## **UPC CUPS Release Change Reference, Release 21.28**

**First Published:** 2022-09-29

This RCR describes new and modified feature and behavior change information for the 21.24.x CUPS releases.

Figure 1: Multiple DRA Call Flow in CUPS

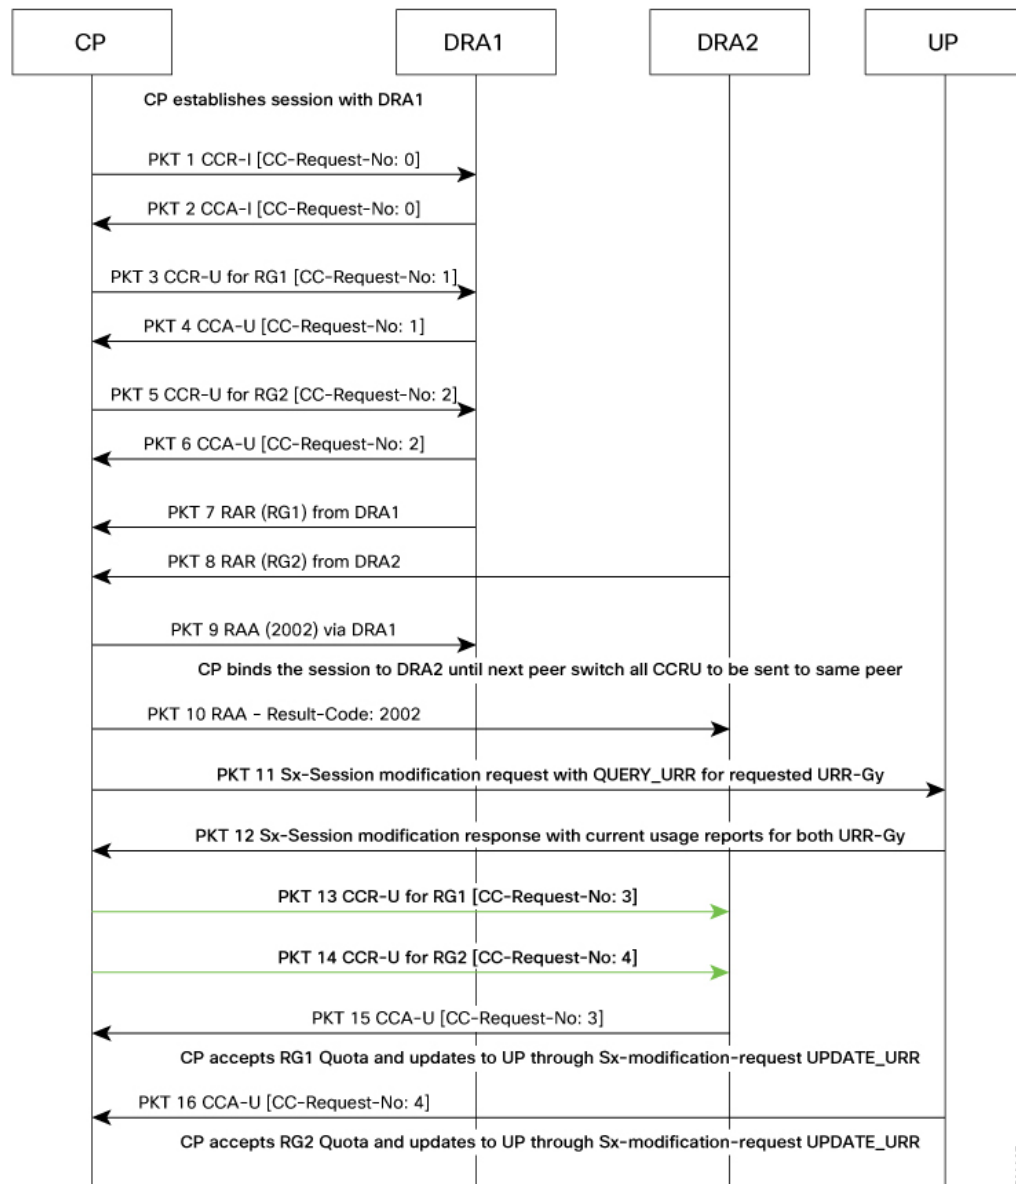
In CUPS, the user plane fetches every CCR-U that is sent along with the current usage report. During collision, if more than one specific RAR is received at the same time from different DRAs for the respective rating groups, the control plane marks the Gy-URR buckets, and sends Sx Session Modification Request to the user plane. The user plane sends back the current usage reports to the control plane for the requested Gy-URR bucket in Sx Session Modification Response. If RAR is received from different DRAs, the peer switch happens. In CUPS, each CCR-U with FORCED REAUTHORIZATION for the requested rating groups is sent to the peer DRA of the latest path switched.

The following call flow illustrates how P-GW accepts both RGs from different peers.
